Subject: Final Rule, Response to Petitions for Reconsideration, Technical Amendment, Docket No. 2008-0111, Anthropomorphic Test Devices; ES-2re Side Impact Crash Test Dummy 50th Percentile Adult Male.

First Technology Safety Systems (FTSS) has reviewed the February, 2008, ES-2re dummy drawing package (identified in the above mentioned technical amendment) and we have identified a number of drawing errors and a number of drawing issues. We seek to petition NHTSA to correct these drawings to ensure that the ES-2re dummy continues to meet the same dimensional and performance requirements established for the dummy when the dummy was proposed for inclusion into 49 CFR Part 572 Subpart U. FTSS makes the following comments and recommendations with respect to the drawing package. A marked up drawing for each of these recommended changes are attached to the end of this letter.

SECTION A-A

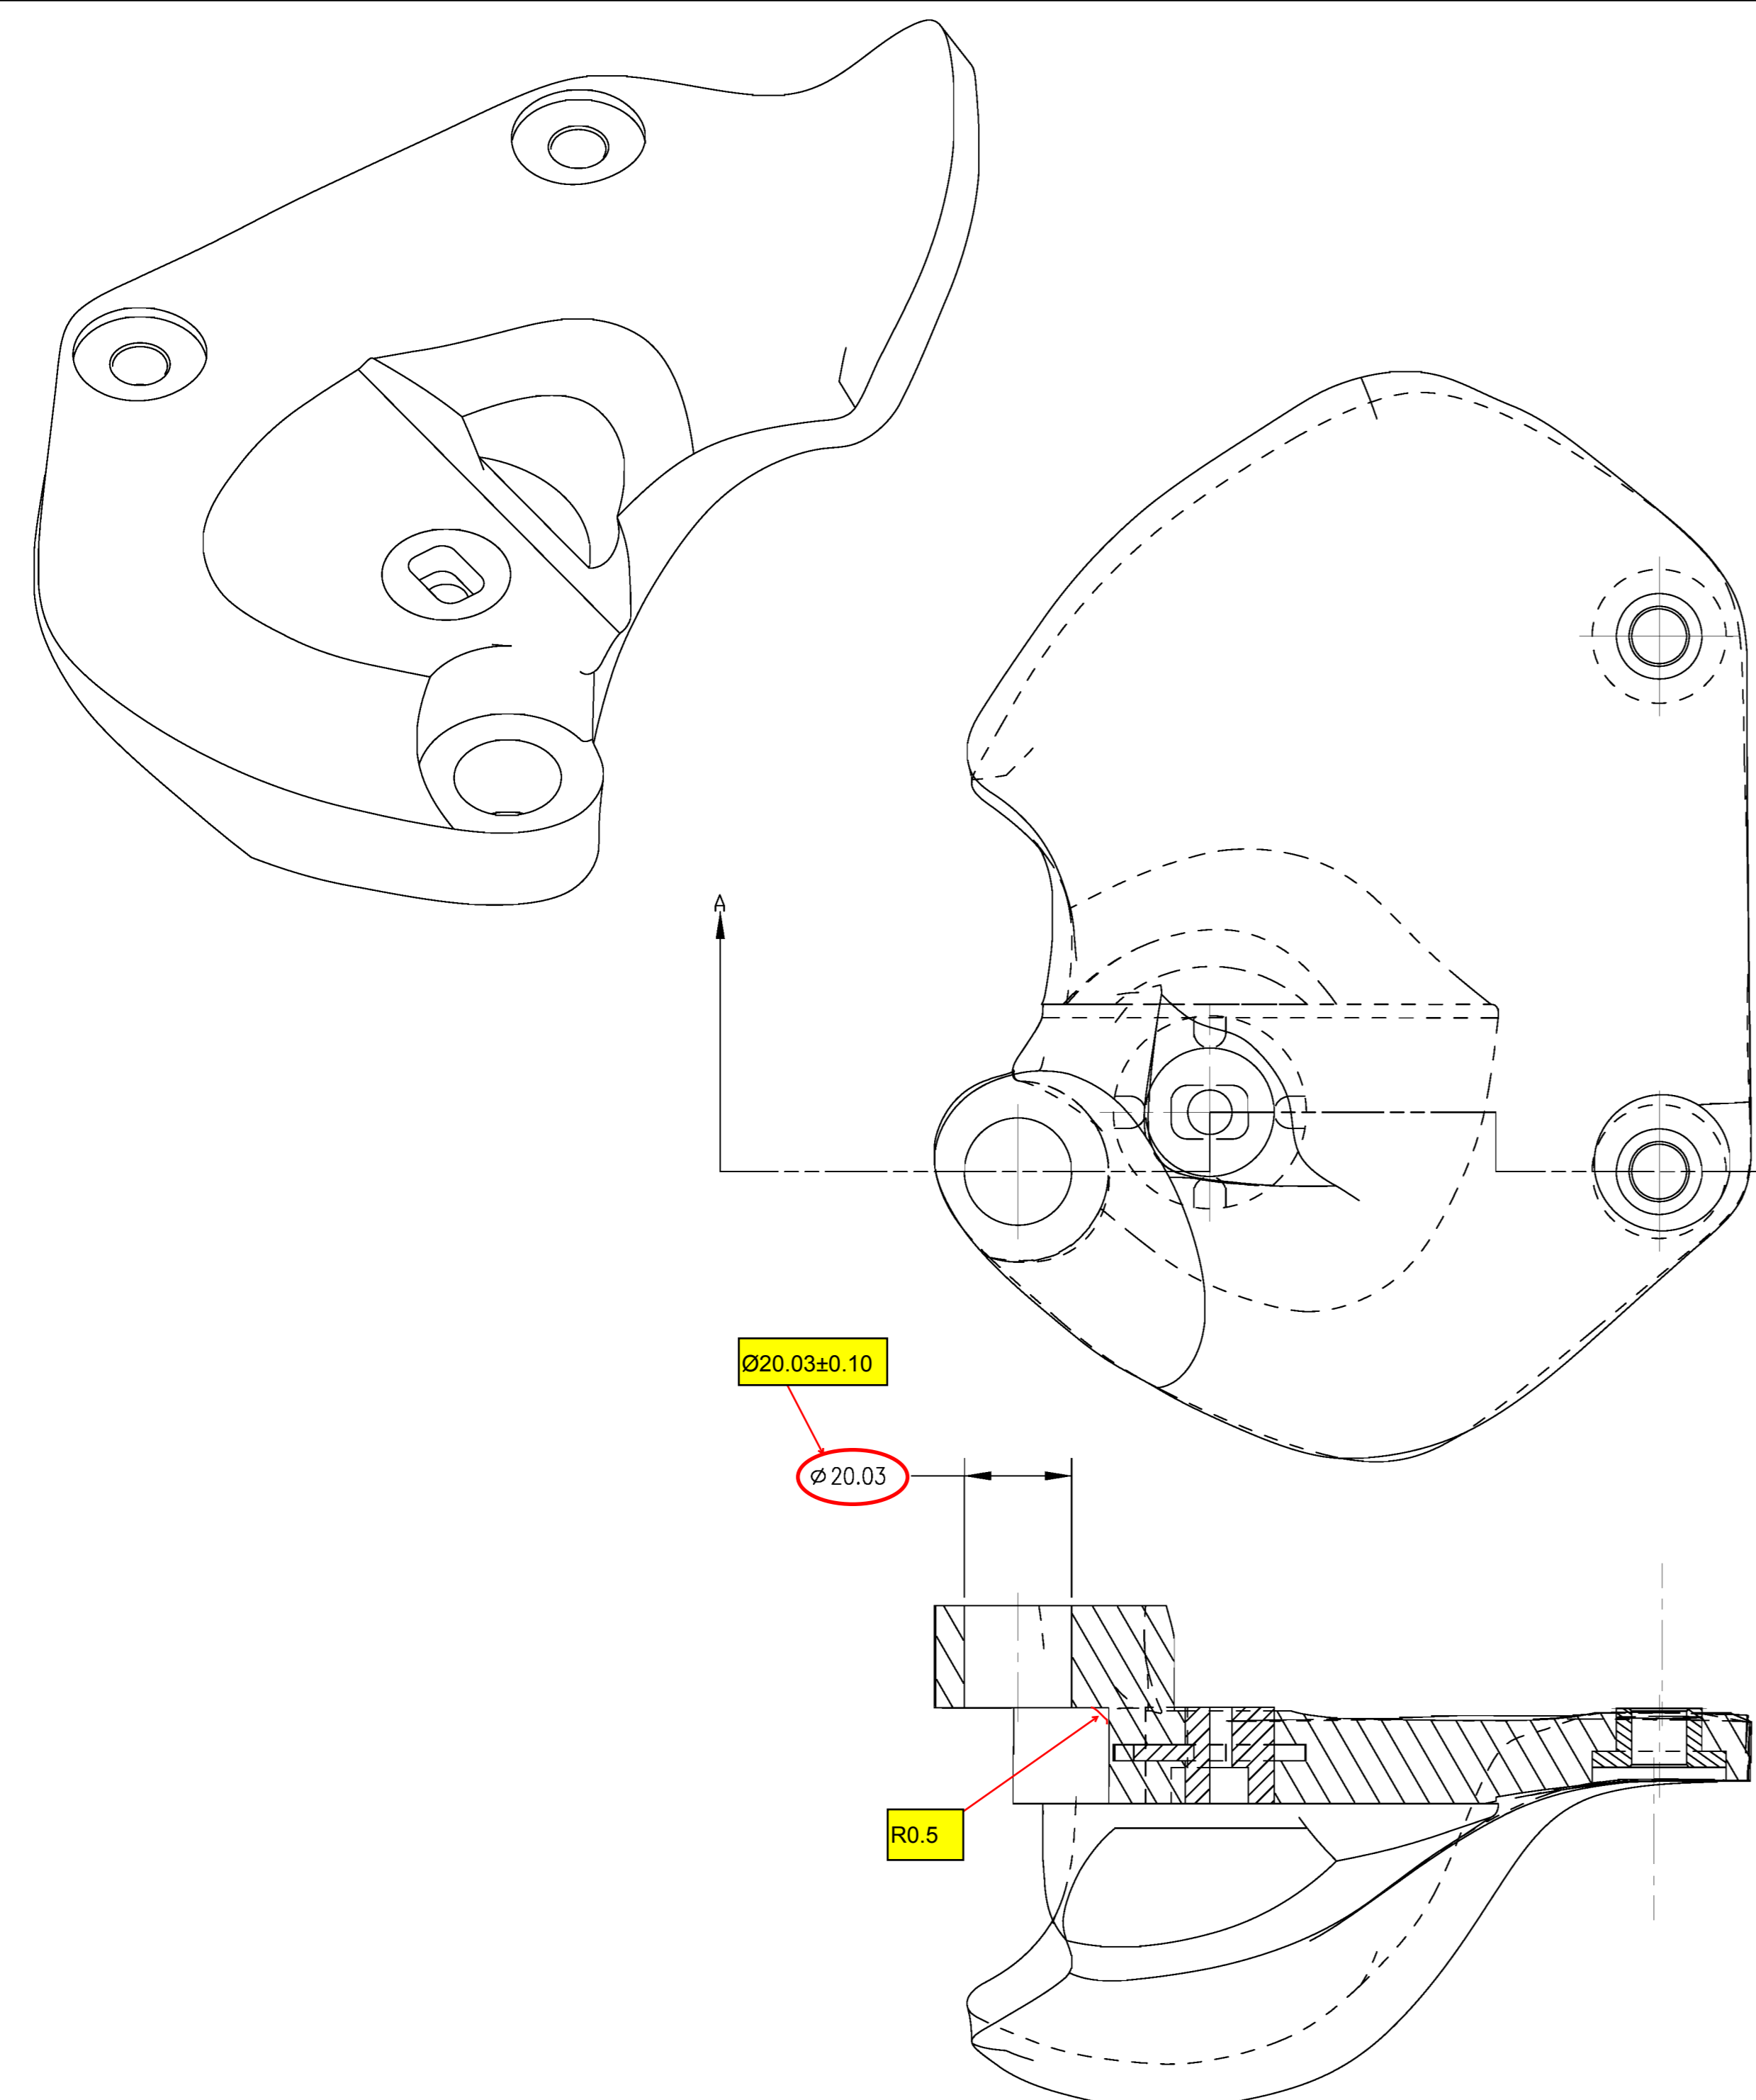
- 8) Drawing 175-6002, Iliac Wing Assembly, Right. FTSS recommends that the drawing dimension $\text{Ø}20.03$ " be replaced with $\text{Ø}20.03 \pm 0.10$ " since this dimension cannot be controlled to ± 0.05 . We also recommend the addition of dimension $R0.5$ " to better define this location for easier machining of this particular section of the part and to prevent breakage due to concentrated stresses.

PLATE, NECK HEAD & TORSO INTERFACE

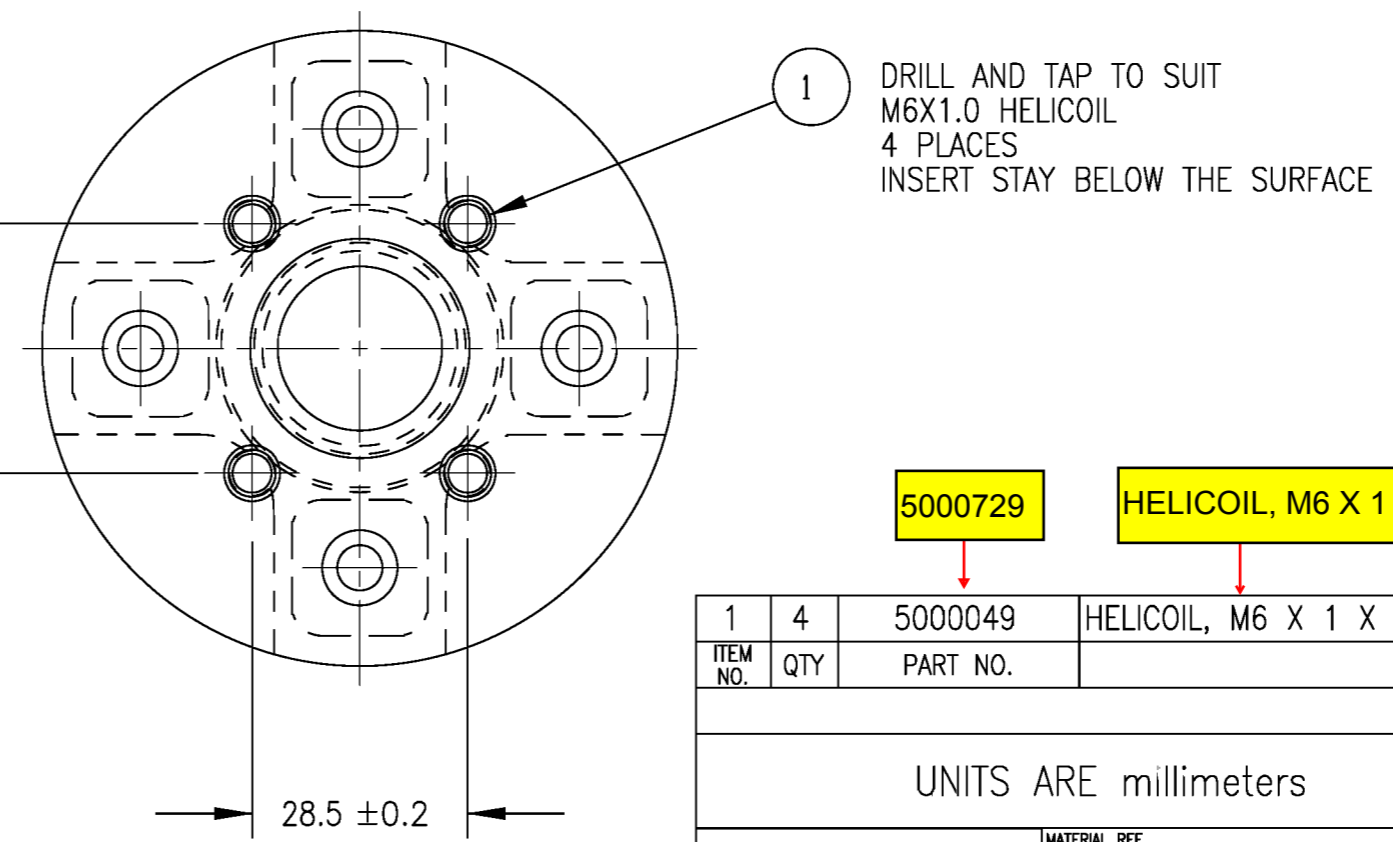
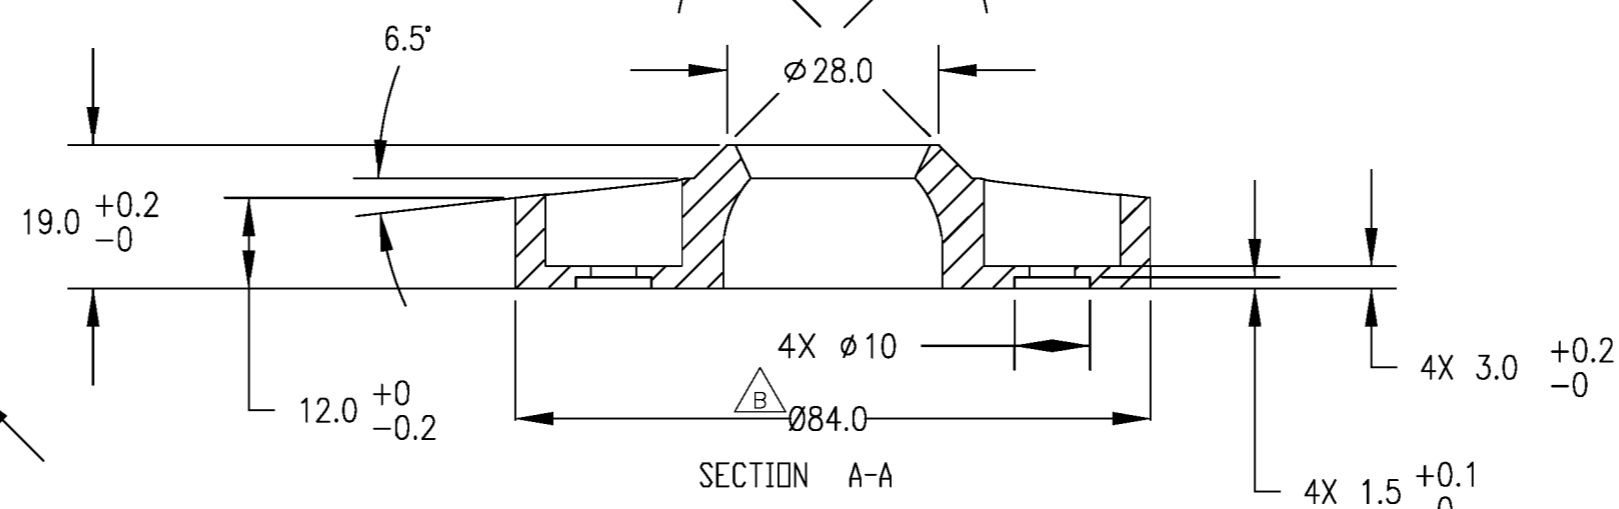
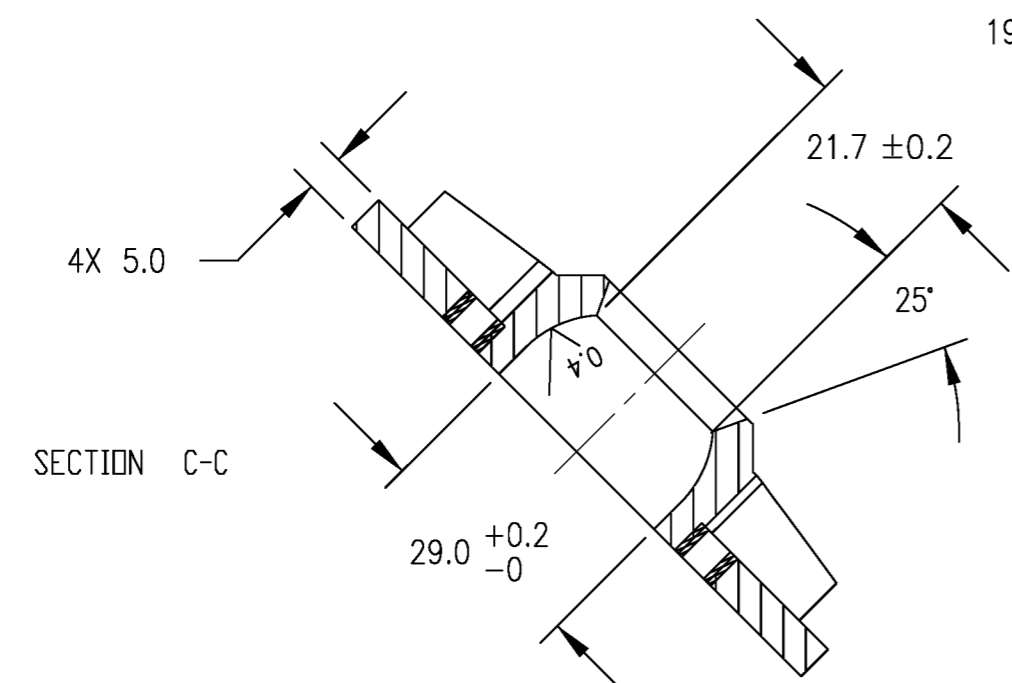
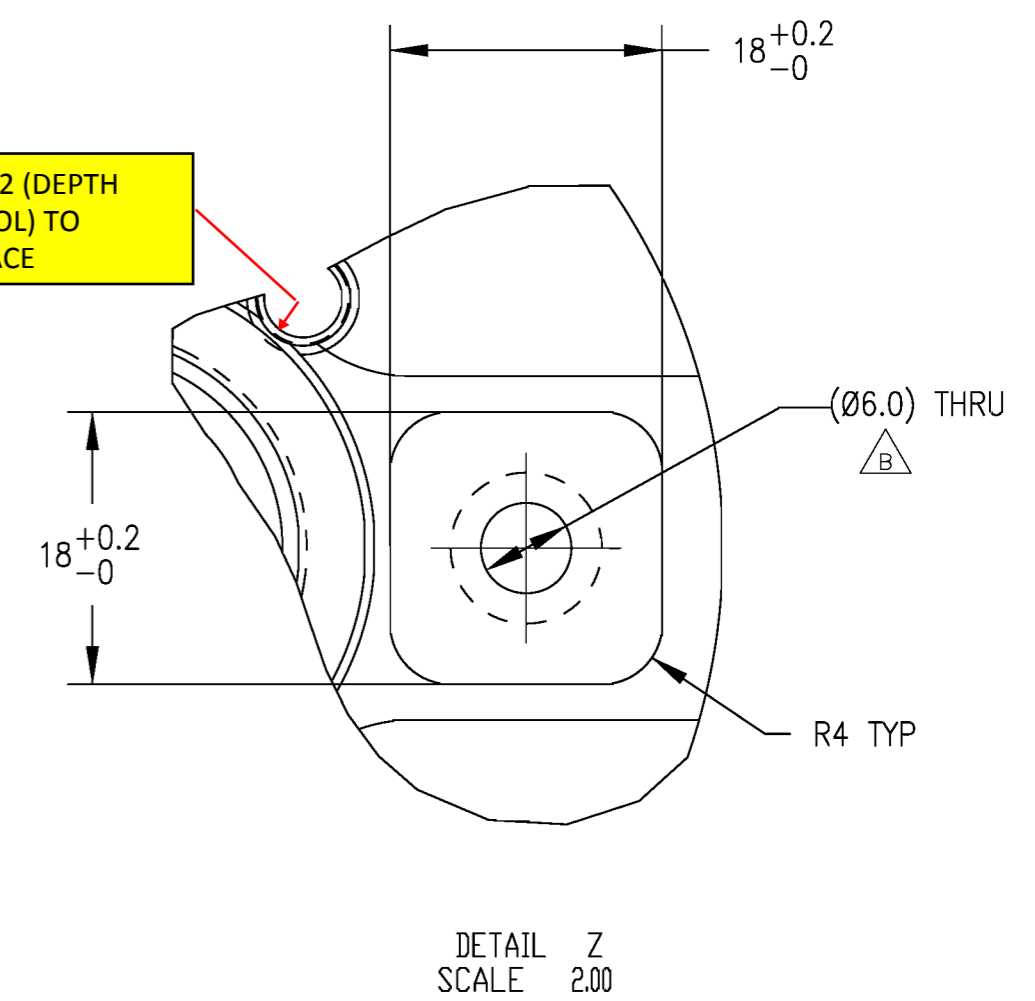
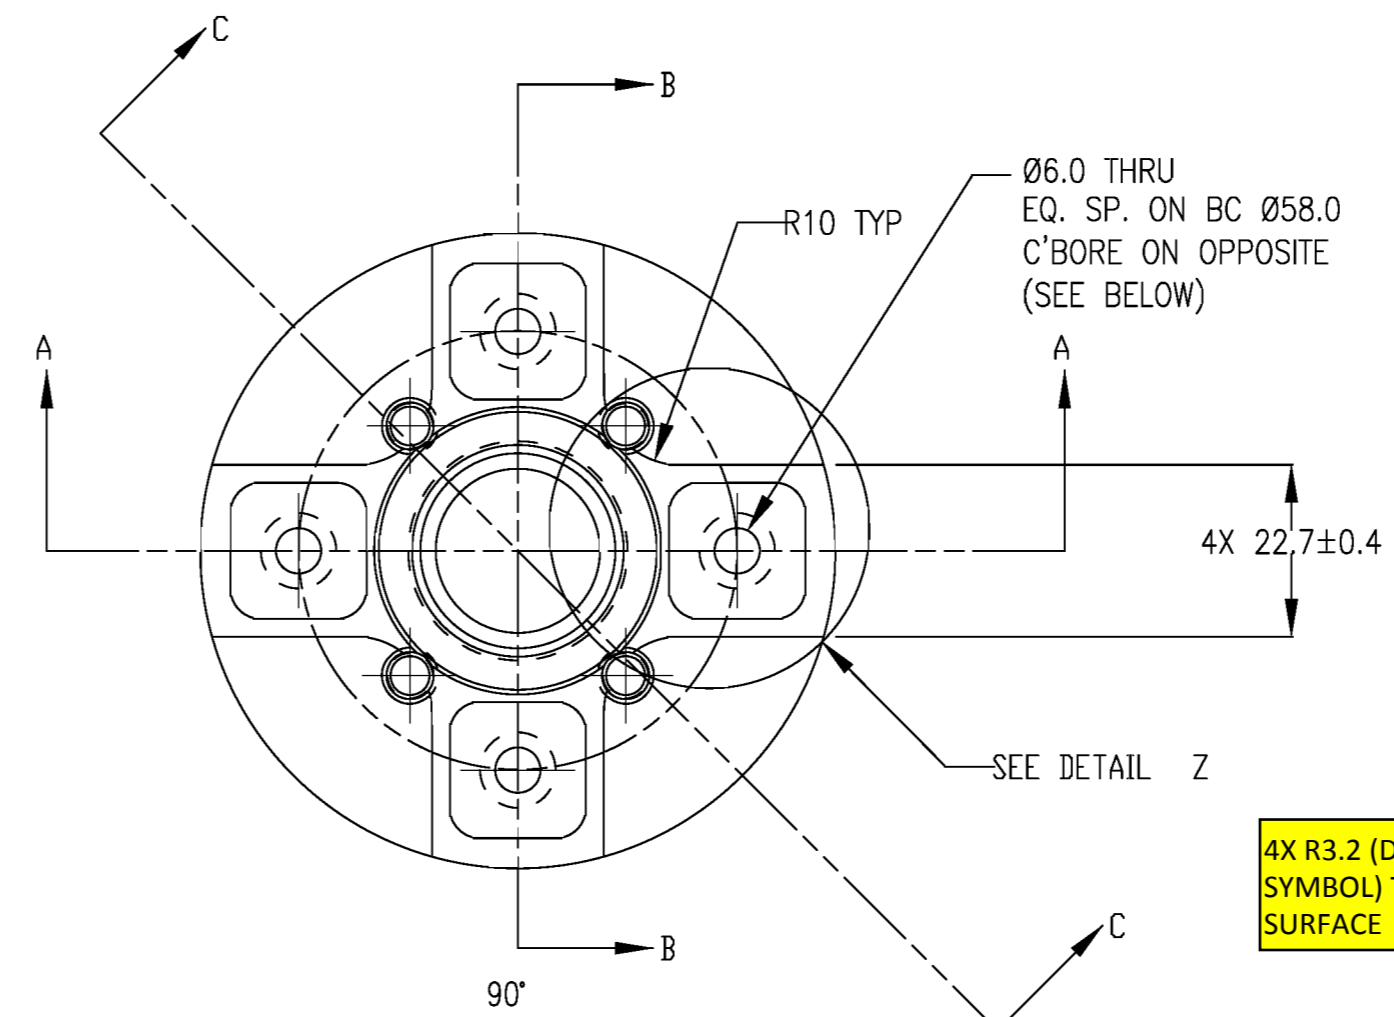
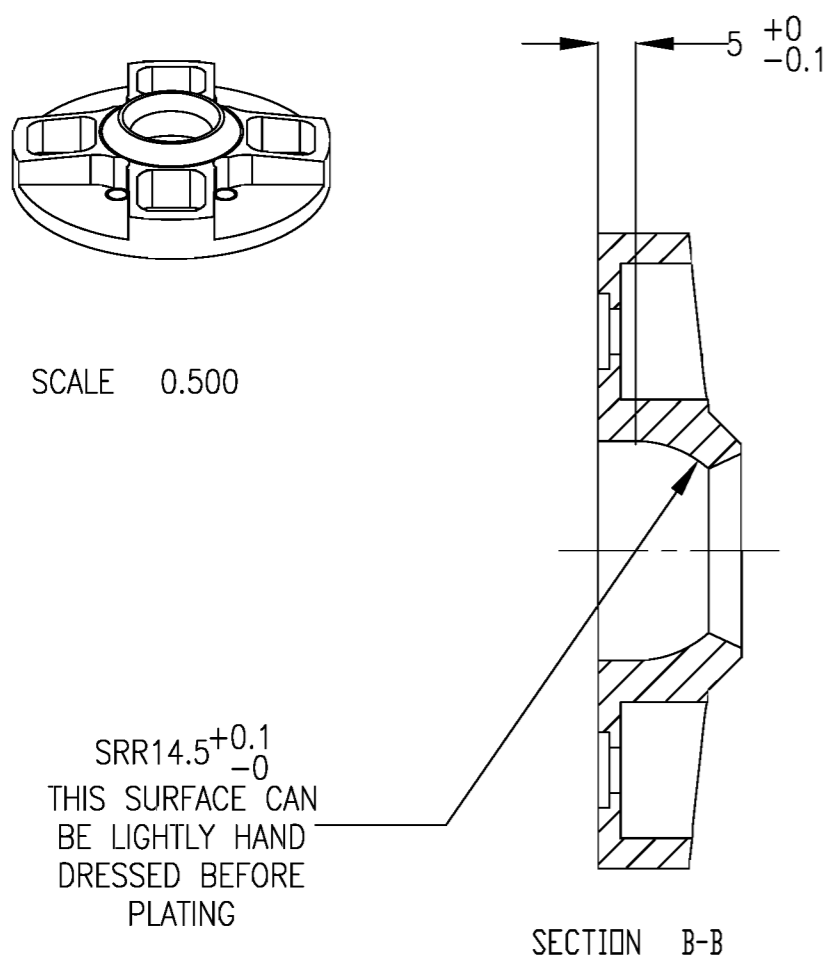
- 9) Drawing 175-2003, Plate, Neck Head & Torso Interface. FTSS recommends that NHTSA part number 5000049 Helicoil, M6 x 1 x 6, be replaced with part number 5000729 Helicoil M6 x 1 x 4.5 because the 5000049 Helicoil is too long and may not sit below the machined surface due to stack up tolerance of parts. FTSS also suggests the addition of dimension $4X R3.2 \text{ } \nabla \text{ to the Surface}$ " on Detail Z in order to clarify the dimension.
